RE: ASHTABULA COUNTY
CITY OF GENEVA
~~CORK ELEMENTARY~~ *Geneva MS*
NPDES PERMIT NO. OHC000003
OHIO EPA PERMIT NO. 3GC04368*AG
CONSTRUCTION STORM WATER

On July 27, 2011, Ohio EPA conducted an inspection of the Geneva Middle School project located at 839 Sherman Street, City of Geneva, Ashtabula County, Ohio. Ohio EPA records indicate that the site is covered by the General National Pollutant Discharge Elimination System (NPDES) Permit for Storm Water Associated with Construction Activity (General Storm Water Permit), permit No. 3GC04368*AG. On site, I spoke with a foreman from Pro Quality Excavating, who informed me that Titan Excavating is responsible for the sediment basin and other sediment and erosion controls for the site. The inspection documented the following:

Figure 1. The outlet structure is not installed properly.

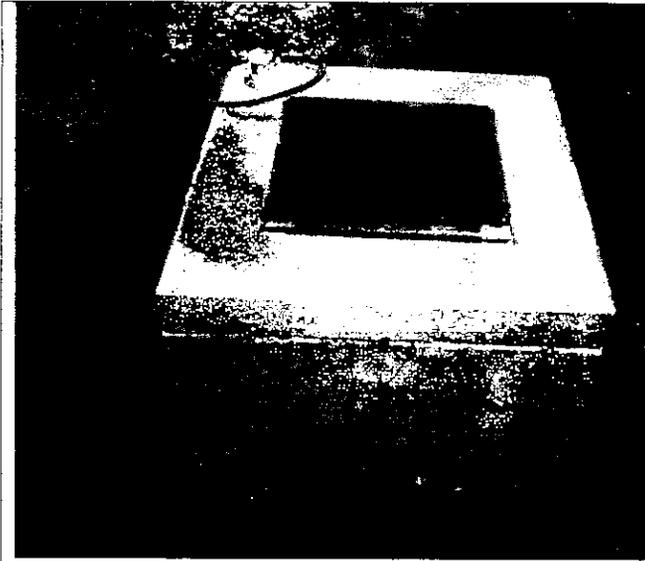
- **The outlet structure for the sediment basin was not installed properly and had no dewatering structure in place during construction activities.**
 - The outlet structure for the sediment basin was not installed correctly. In addition, there was no dewatering structure in place during construction activities to ensure proper draw down times and maximum removal of sediment such as a riser pipe or skimmer device. Please install the outlet structure and dewatering device with specifications detailed in the SWP3 immediately (See Figures 1 & 2).

Figure 2. The sediment basin has no dewatering structure for during construction.
